PROJECT NAME: Paul Hopkins Park Pedestrian Bridge

SOLICITATION NO: B191052

RE: ADDENDUM #1

GALVESTON COUNTY PAUL HOPKINS PARK PEDESTRIAN BRIDGE

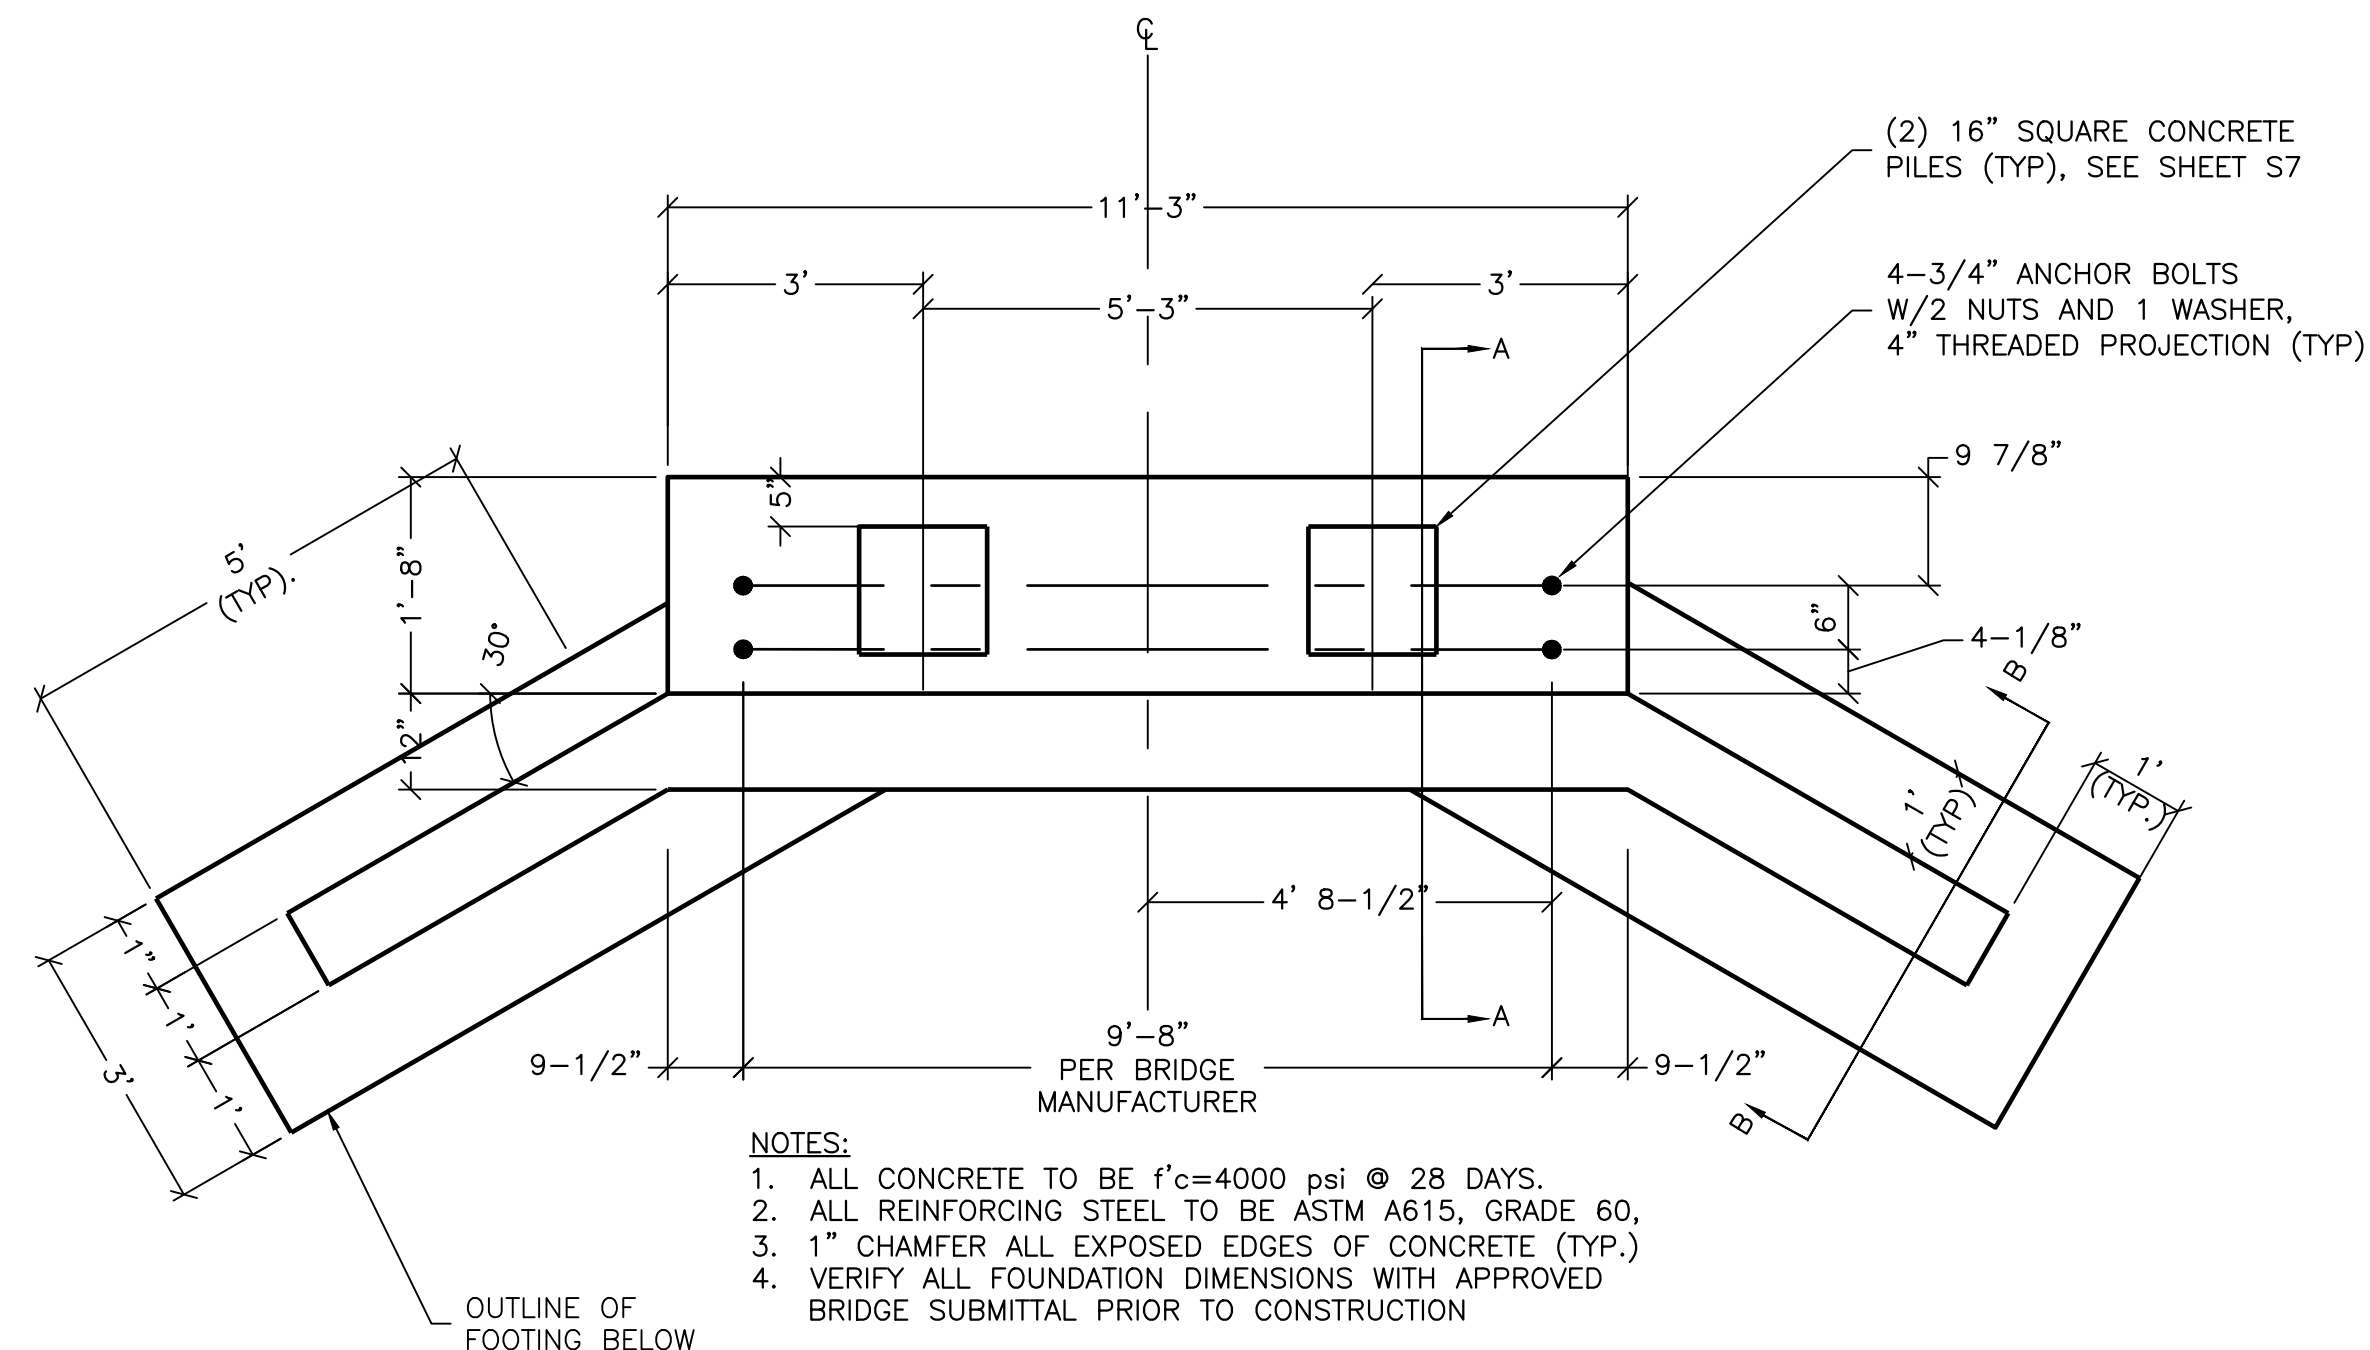
Question #2: Plans show a 90 psf live load. Specs have a 65 psf.

Question #3: Plans show a 10,000 lb vehicles. Specs have a 5,000 lb vehicle.

Question #4: Plans show Horizontal Rails. Specs call out a Vertical Picket system.

Question #5: Plans show an H-section Bridge. Specs call out an Underhung Bridge.

Question #6: Plans call out a 1/2" min. wall. Specs call out a 3/16" wall.

Response: The bridge shall be designed for a live load of 90 psf.

Response: The bridge shall be designed for a 10,000 lb vehicle load.

Response: Horizontal safety rails shall be placed on the inside structure on both sides the bridge up to a minimum height of 42" above the deck surface. Safety rails shall be placed so as to prevent a 4" sphere from passing through the rails. Safety rails shall be 1-1/4" x 1-1/4" x 1/8" angle.

Response: Bridge shall be an H-section Bridge

Response: Minimum wall thickness shall be 1/2".

1 CANOPY PLAN VIEW ALTERNATE #1

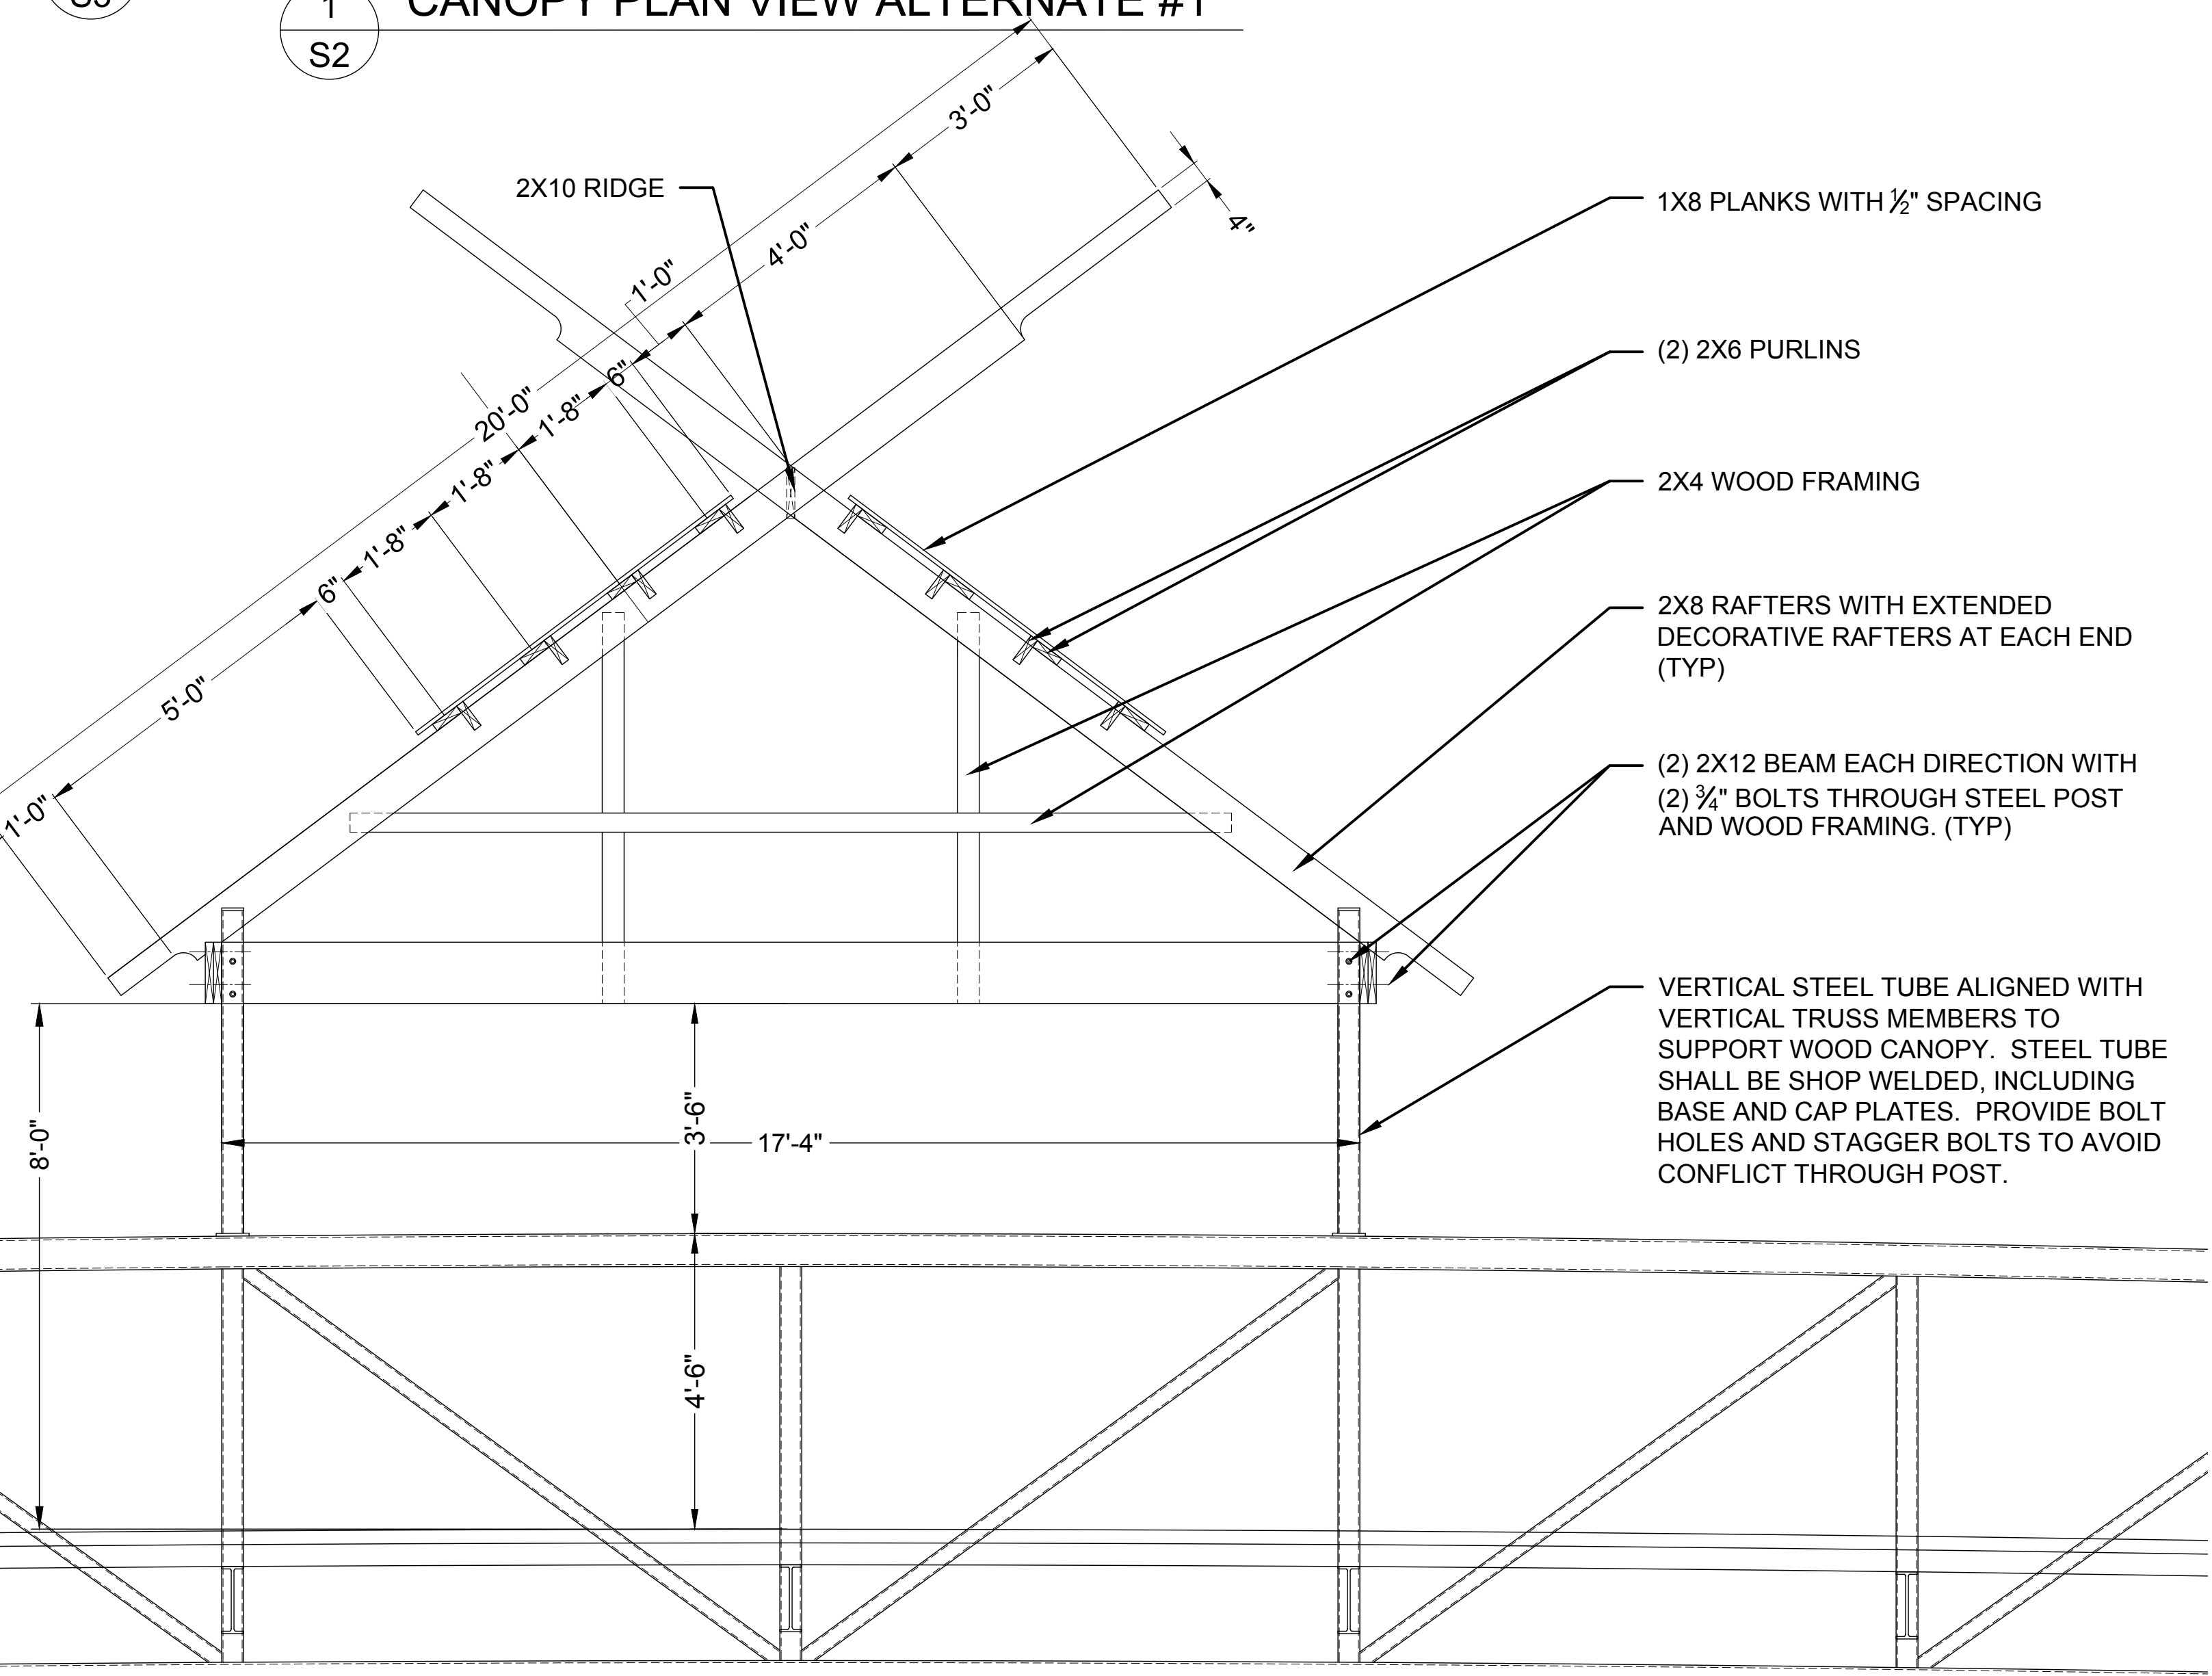
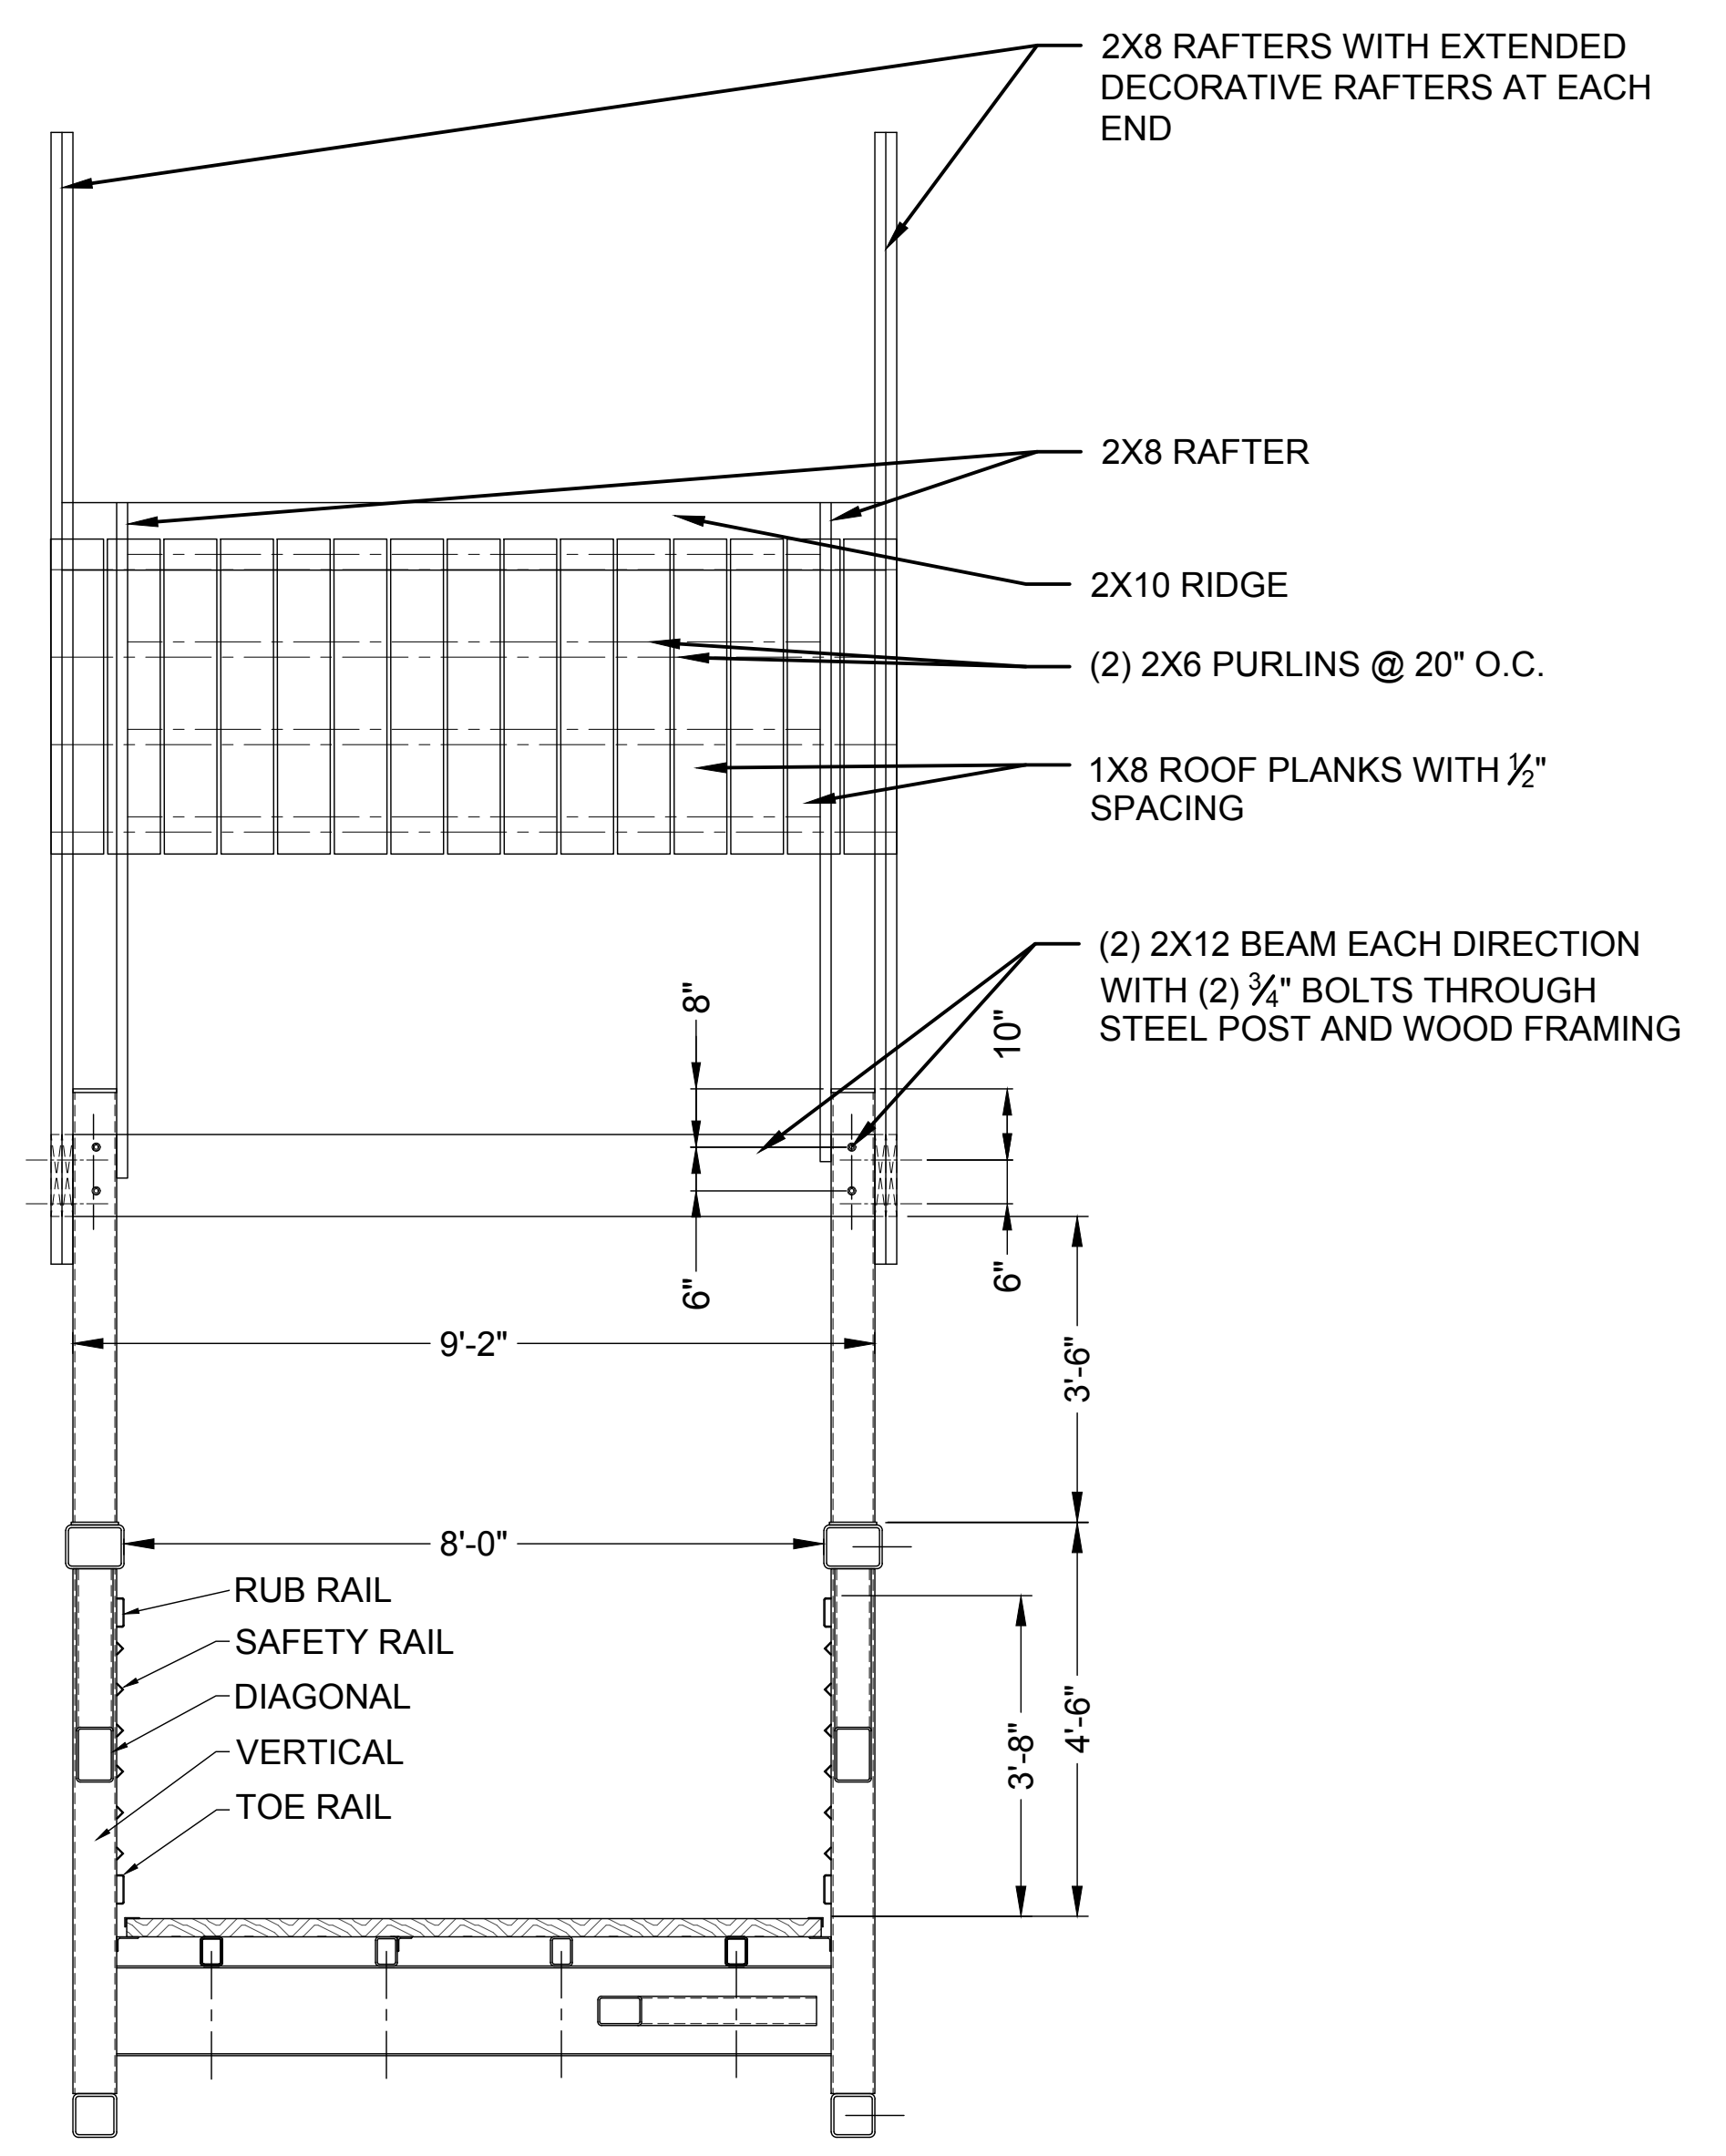
Question #2: *On sheet 56, Detain 2, what size is the Vertical Steel Tube and truss members to be:*

Response: The Vertical Steel Tube and truss members are to be sized per bridge manufacturer's structural engineer.
